## ADDENDUM NUMBER 3

**1.01 DATE: MARCH 24, 2021**

**1.02 PROJECT: WELCOME CENTER**

**1.03 PROJECT NUMBER: DCM NO. 2020604**

## DETAIL: AUXILIARY LABELING

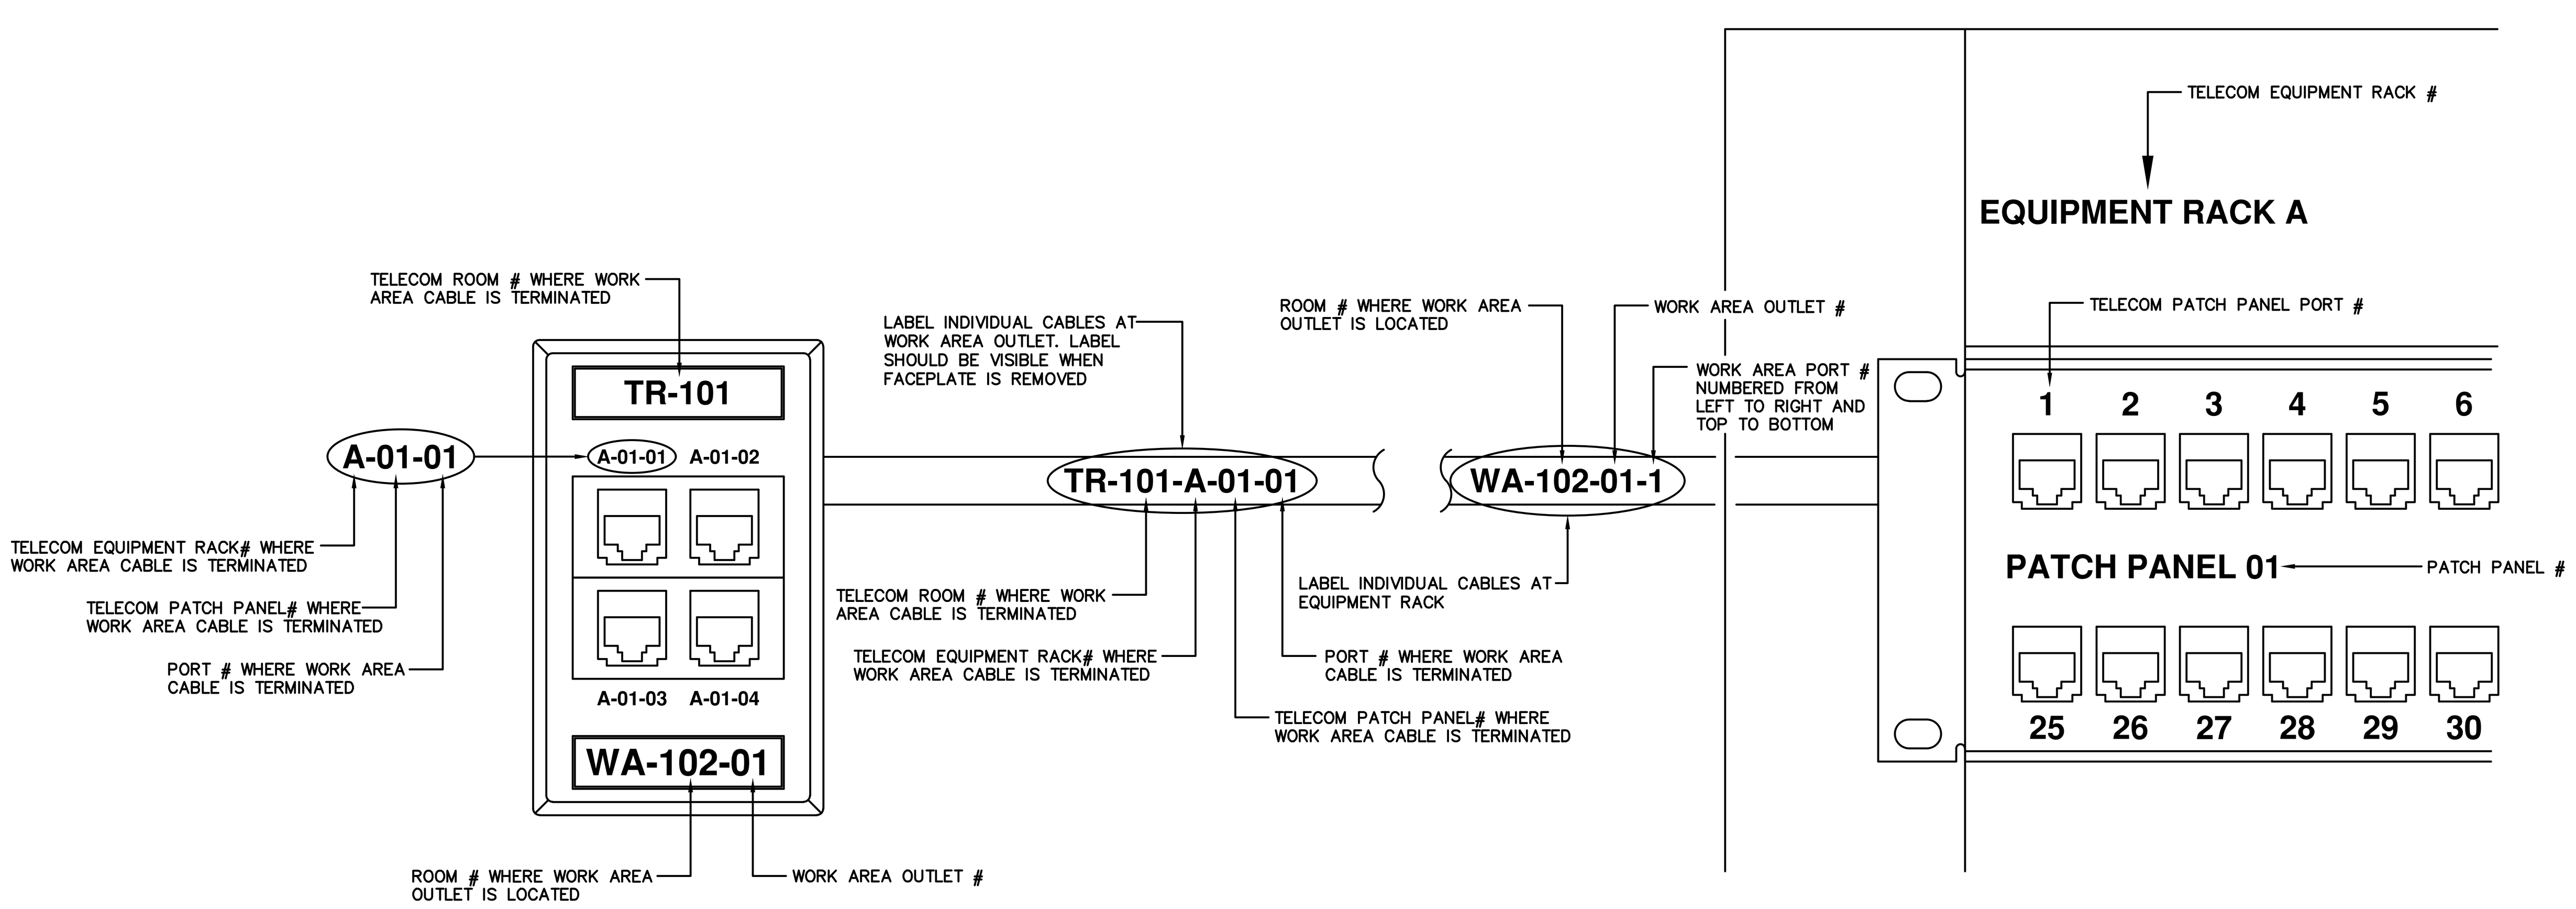
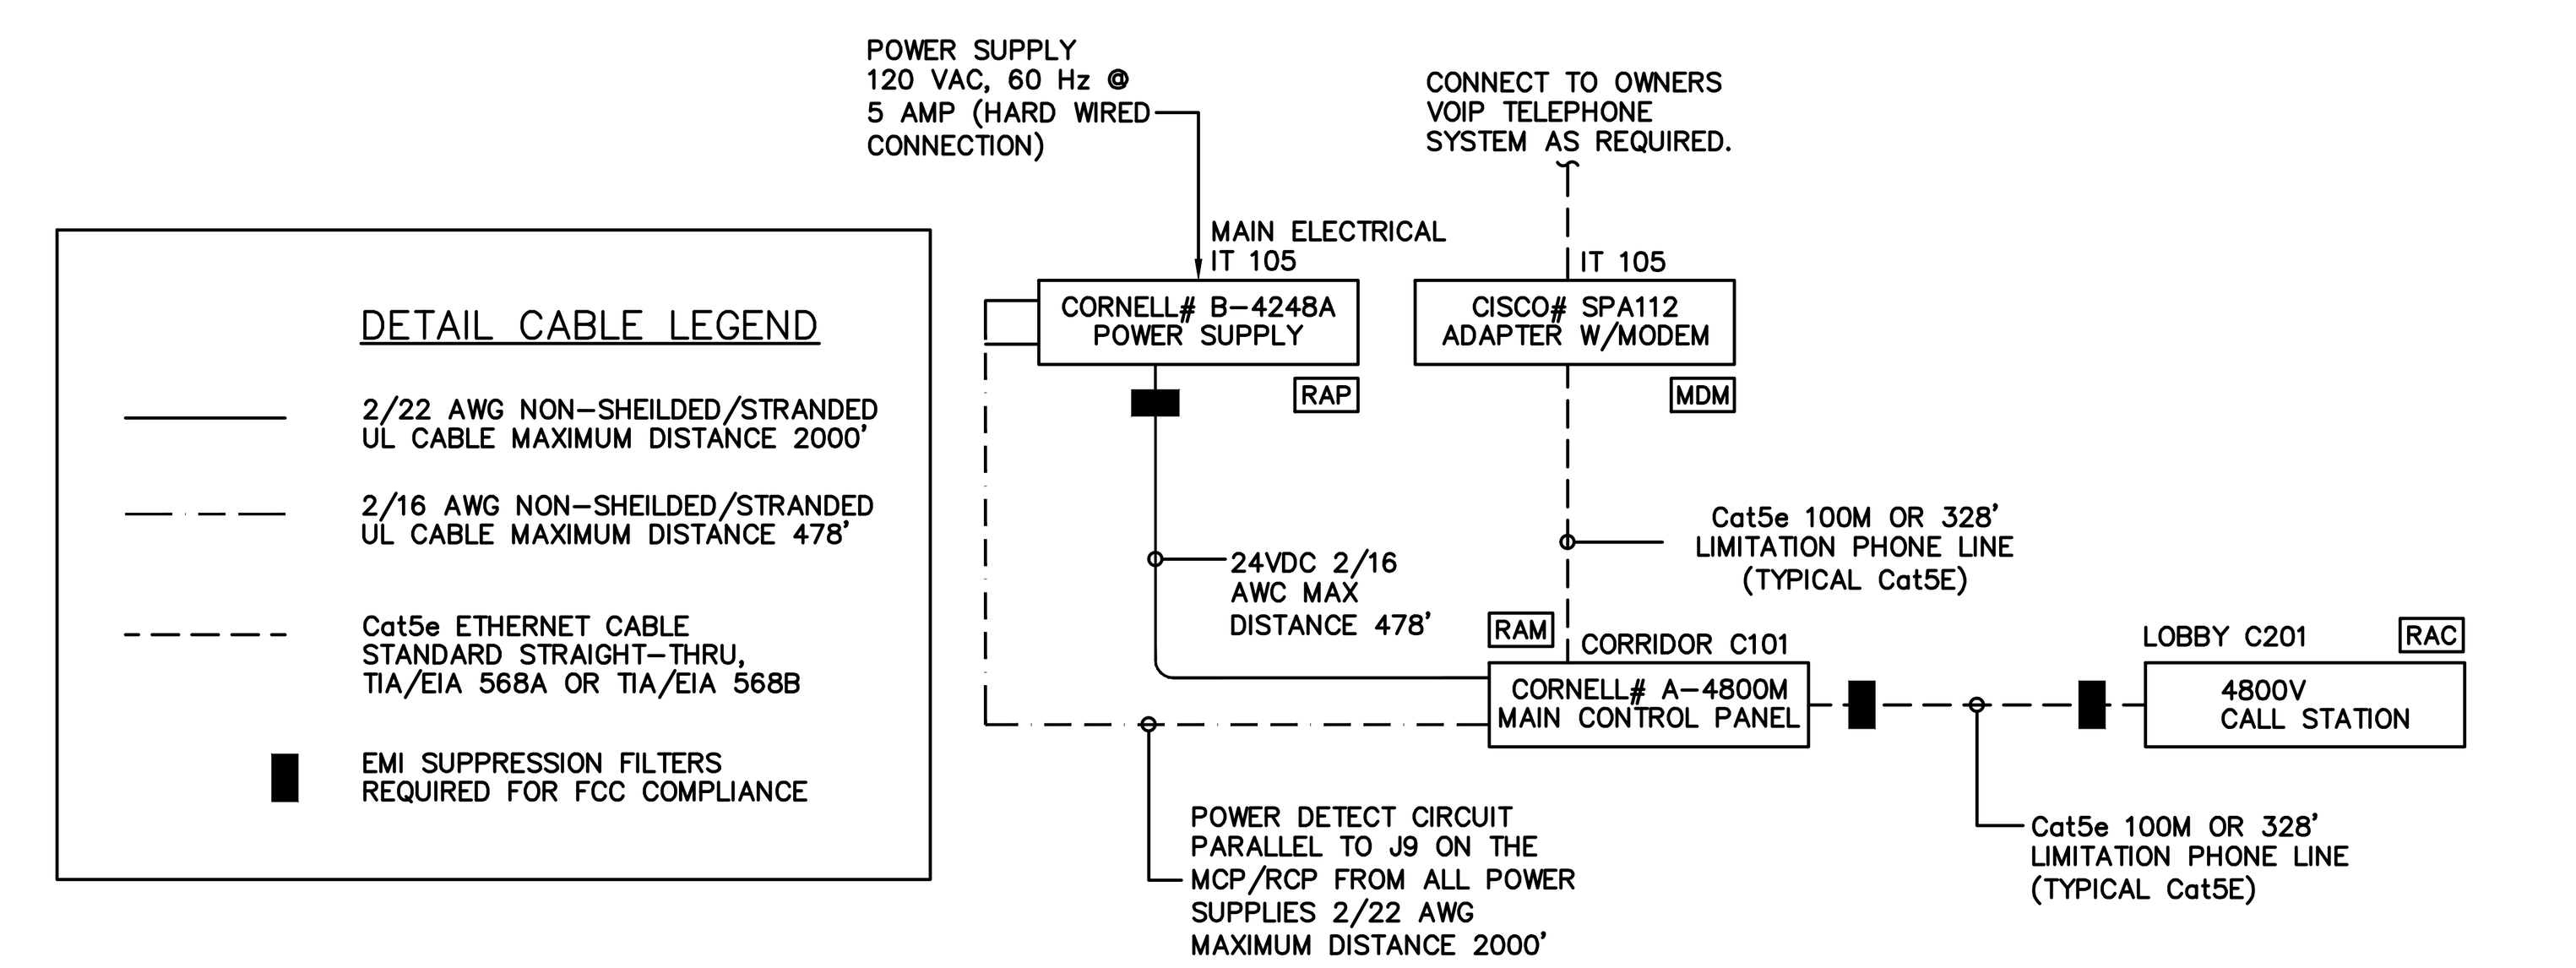
A. Replace this sheet in its entirety. Revisions include the following:
   1. Change reference at auxiliary backboard from IT XXX to IT 105.
   2. Change note number 2 to note number 1. Change notes number 3 and 4 to notes number 2 and 3, respectively.

**4.21 SHEET E-6.1 – FIRST FLOOR PLAN – POWER:**

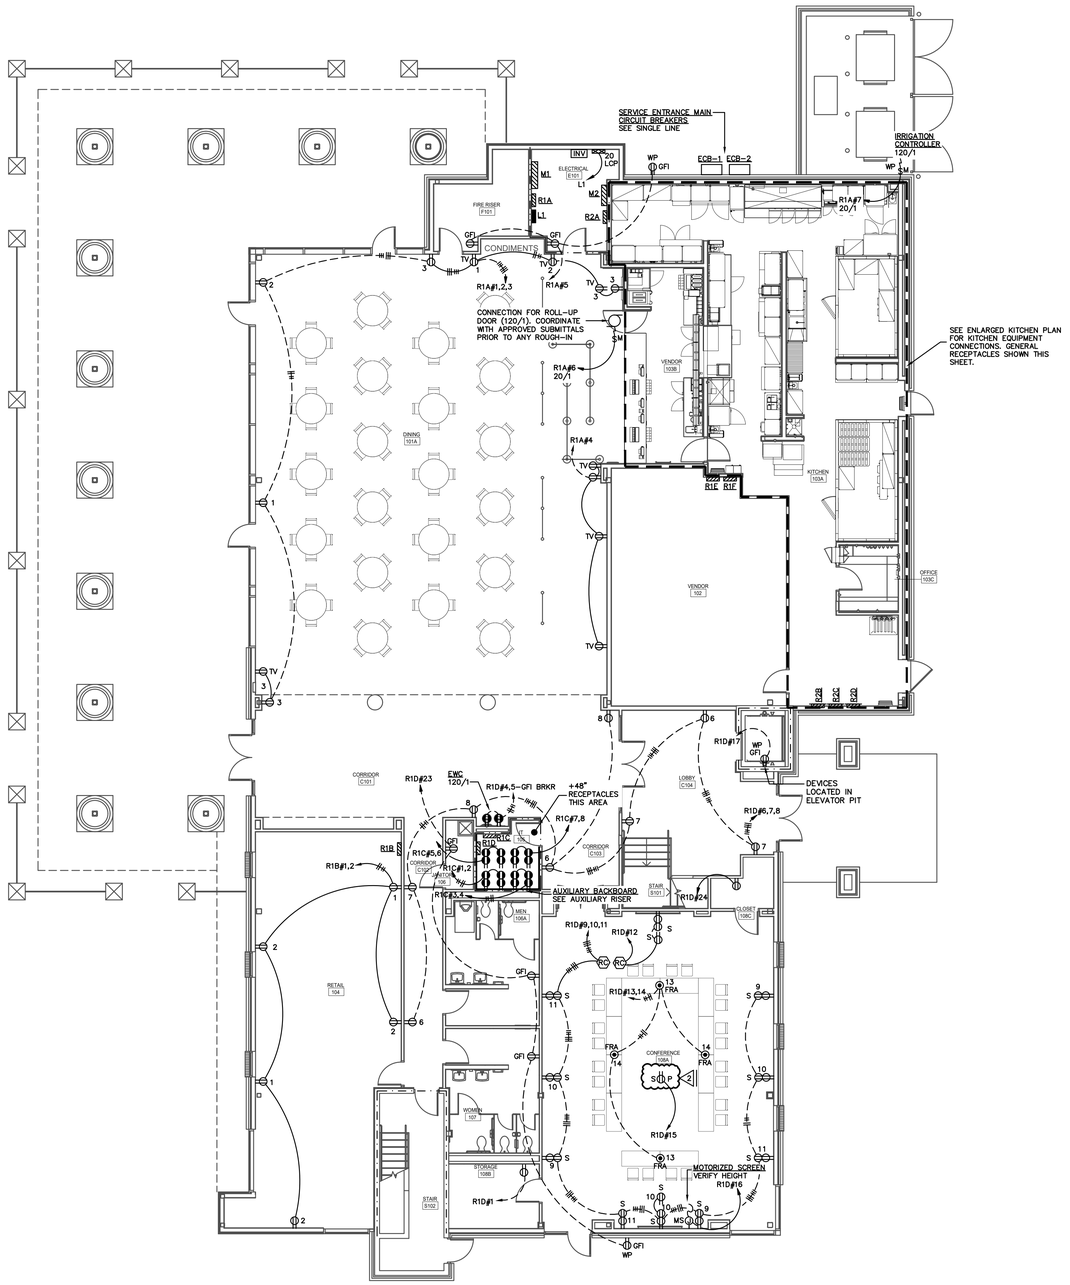
A. Replace this sheet in its entirety. Revisions include the following:
   1. Conference 108A: Change ceiling receptacle to half switched receptacle.

**4.22 SHEET E-6.2 – FIRST FLOOR PLAN – ENLARGED KITCHEN:**

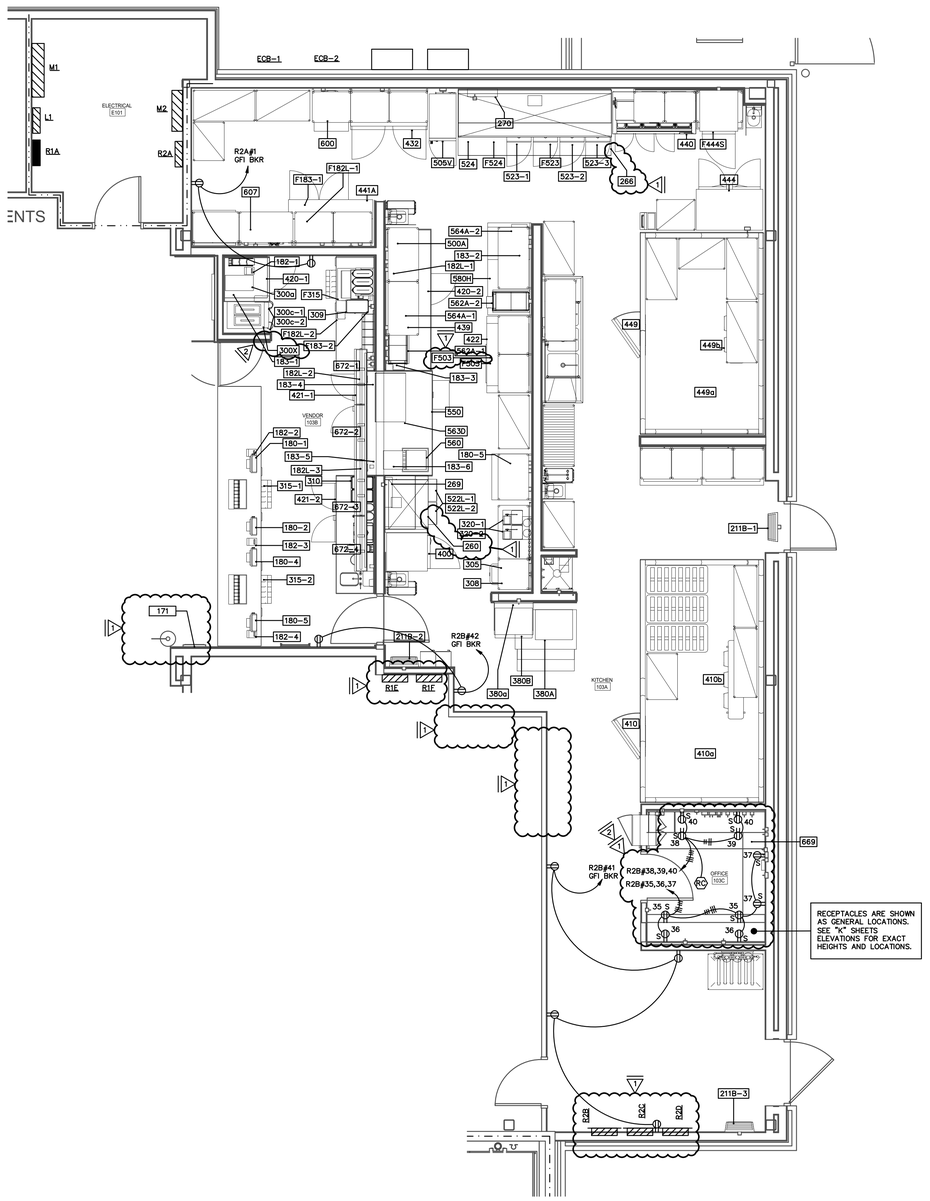
A. Replace this sheet in its entirety. Revisions include the following:
   1. Change all feeder breakers for equipment located under hoods to shunt-trip type breakers and shunt when hood Ansul system is activated.
   2. Delete Items 180-3, 182-4, 503, 183-2.
   3. Item 315-1,3 is a single piece of equipment with 2 connections and has been combined (listing for 315-3 has been combined with 315-1), Item 315-2,4 is a single piece of equipment with 2 connections and has been combined (listing for 315-4 has been combined with 315-2).

**4.23 SHEET E-6.3 – FIRST FLOOR PLAN – AUXILIARY:**

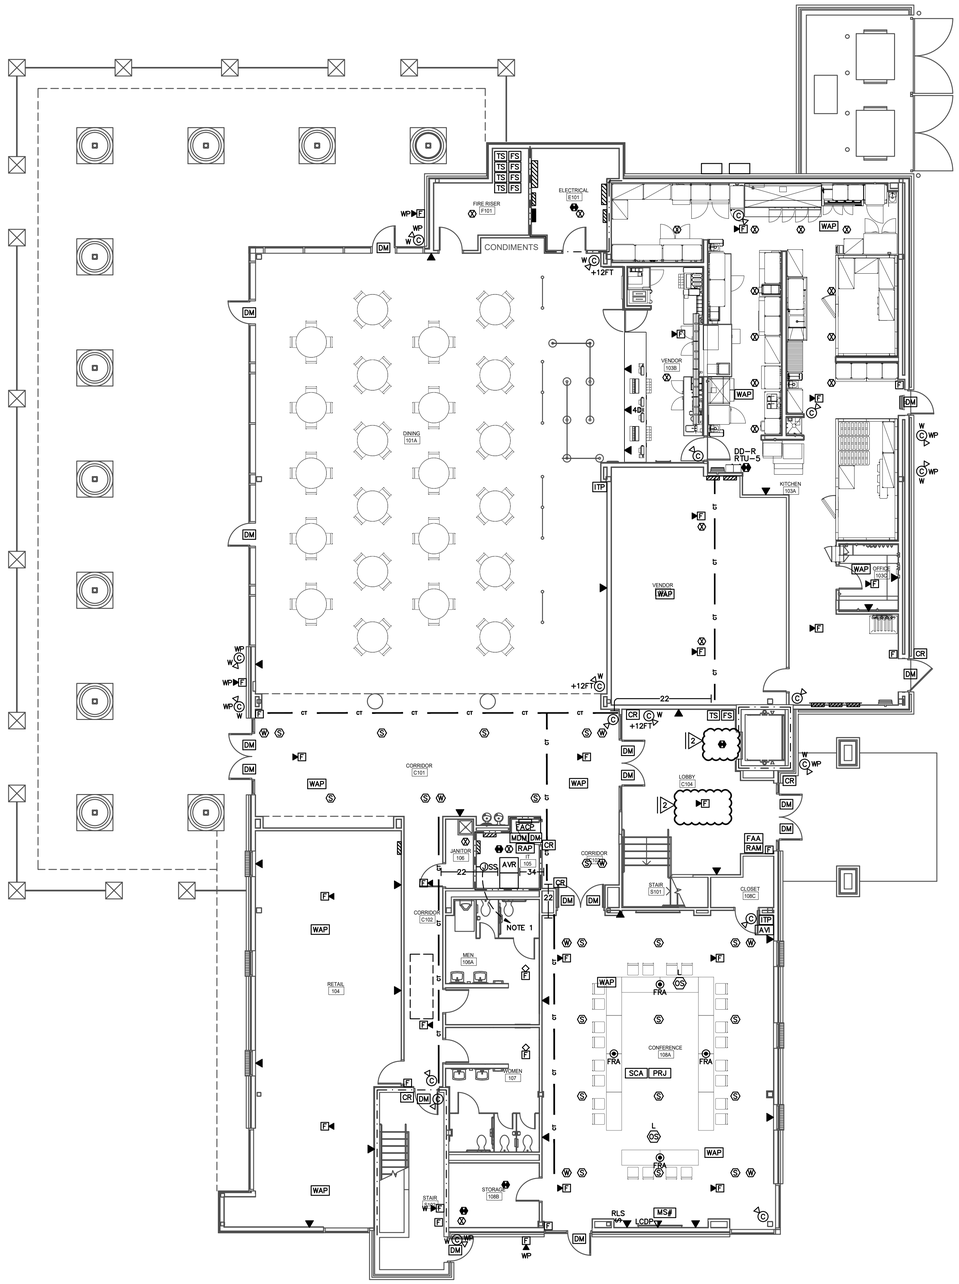
A. Replace this sheet in its entirety. Revisions include the following:
   1. Added Fire Alarm Speaker Strobe in ceiling of Lobby 104.
   2. Added Smoke Detector in ceiling of Lobby 104 outside of Elevator.

**4.24 SHEET E-7.1 - SECOND FLOOR PLAN – POWER:**

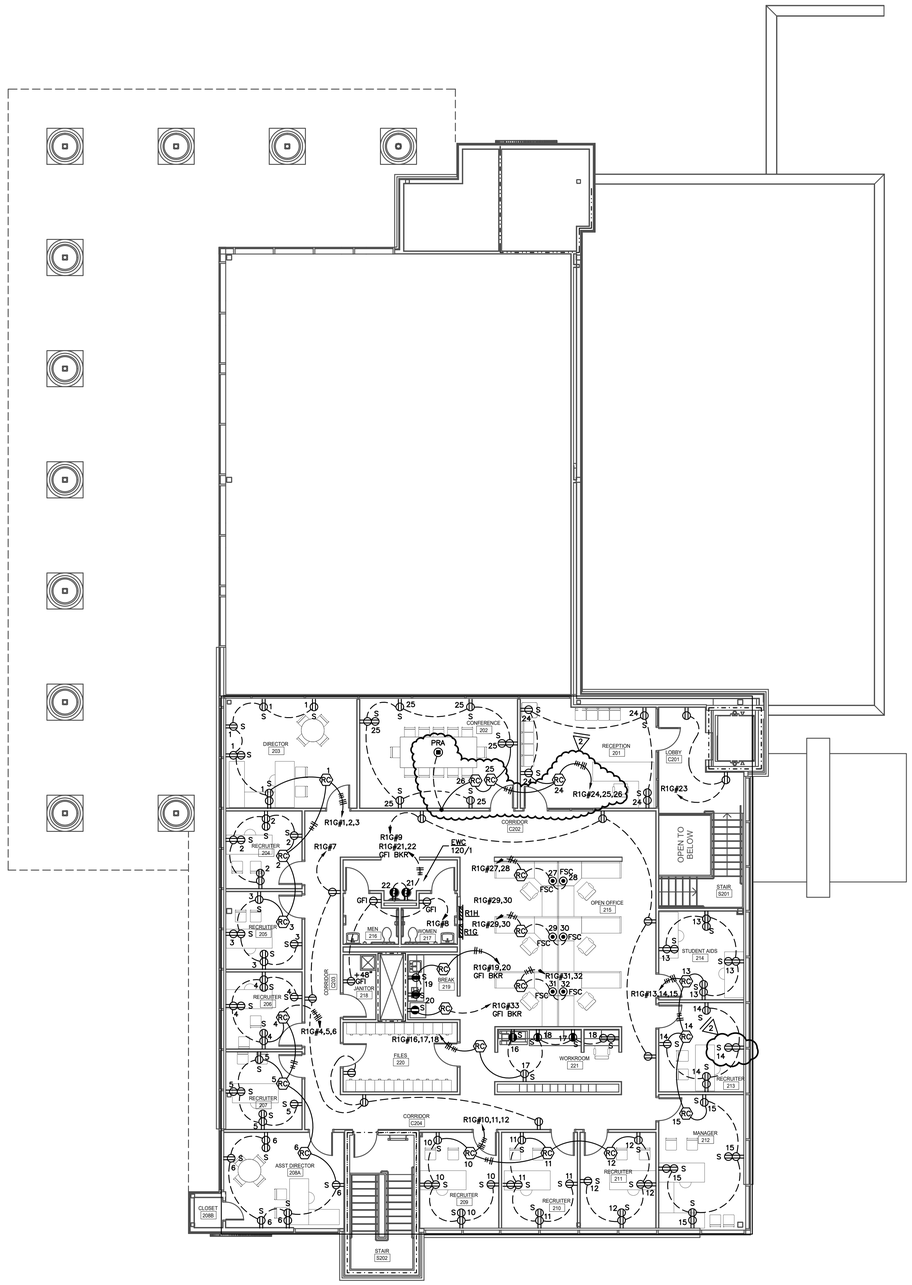
A. Replace this sheet in its entirety. Revisions include the following:
   1. Revised floor box PRA circuiting and connections to reflect changes for switched receptacles.
   2. Added switched double duplex receptacle in Room Recruiter 213.

**4.25 SHEET E-7.2 – SECOND FLOOR PLAN – AUXILIARY:**

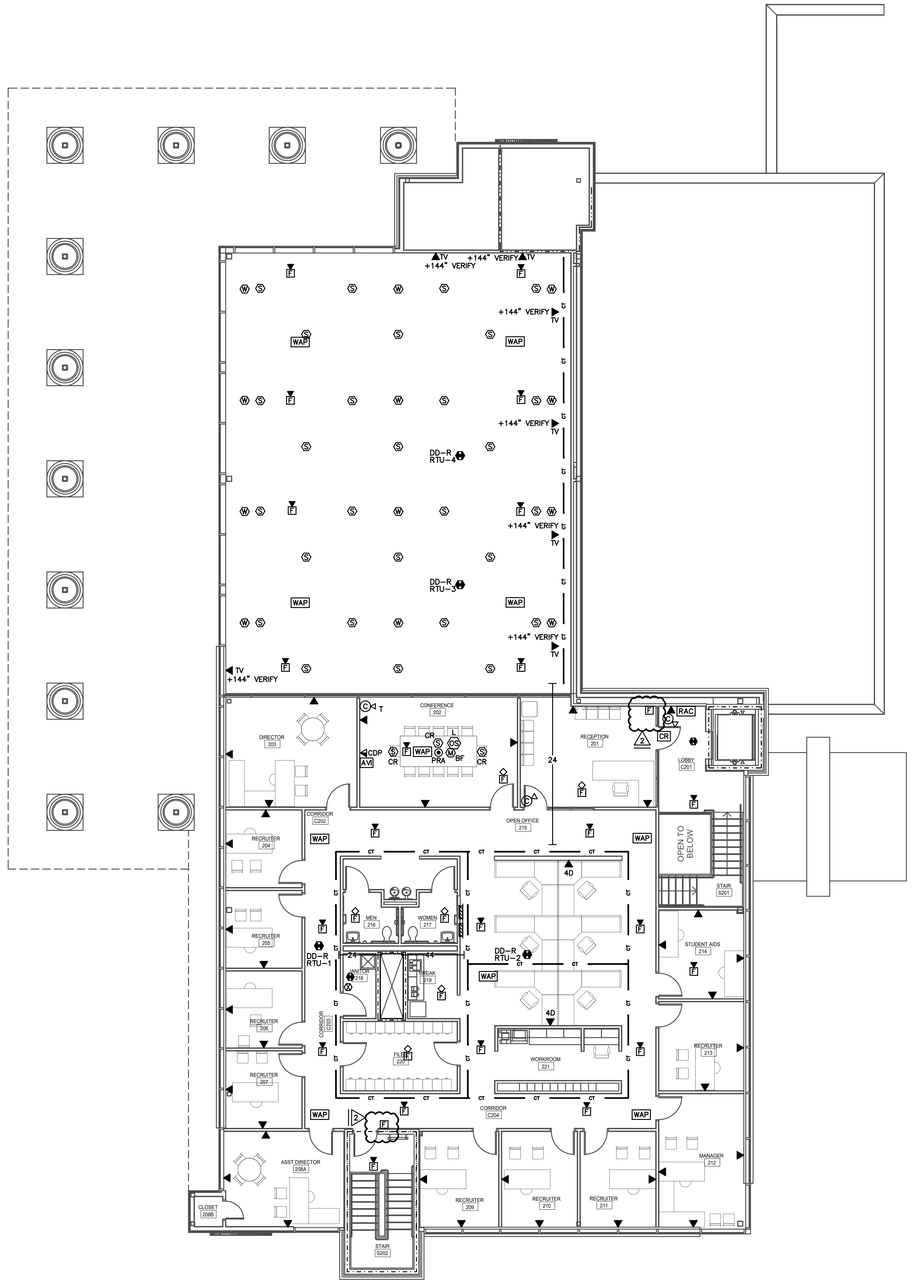
A. Replace this sheet in its entirety. Revisions include the following:
   1. Added Manual Pull Station in Reception 201.
   2. Added Manual Pull Station outside Stair S202.
